State of New Mexico  
 Energy, Minerals and Natural Resources  
**OIL CONSERVATION DIVISION**  
 1220 South St. Francis Dr.  
 Santa Fe, NM 87505

WELL API NO. 30-025-42724
5. Indicate Type of Lease STATE <input checked="" type="checkbox"/> FEE <input type="checkbox"/>
6. State Oil & Gas Lease No. B-1839-1
7. Lease Name or Unit Agreement Name East Vacuum Grayburg San Andres Unit
8. Well Number 5213
9. OGRID Number 217817
10. Pool name or Wildcat Vacuum; Grayburg, San Andres
11. Elevation (Show whether DR, RKB, RT, GR, etc.) 3946' GL

**SUNDRY NOTICES AND REPORTS ON WELLS**  
 (DO NOT USE THIS FORM FOR PROPOSALS TO DRILL OR TO DEEPEN OR PLUG BACK TO A DIFFERENT RESERVOIR. USE "APPLICATION FOR PERMIT" (FORM C-101) FOR SUCH PROPOSALS.)

1. Revised Drilling Program:

**BLOWOUT PREVENTER ARRANGEMENT - 11" 5M BOPE**  
per Onshore Oil and Gas Order No. 2 utilizing 5M Rated Equipment

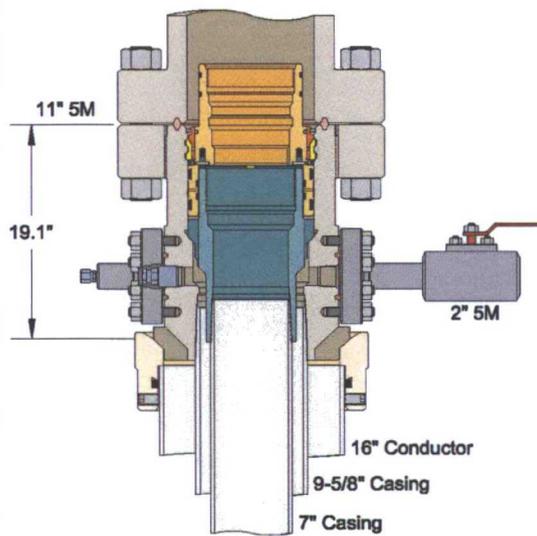
- Revised H2S Plan attached
- New BOP Schematic attached
- New Choke Schematic attached
- Wellhead Schematic attached
- Flex Hose Certification attached
- The well may be drilled utilizing the drilling technique "drilling-with-casing". *BELOW APPROX 4100'*
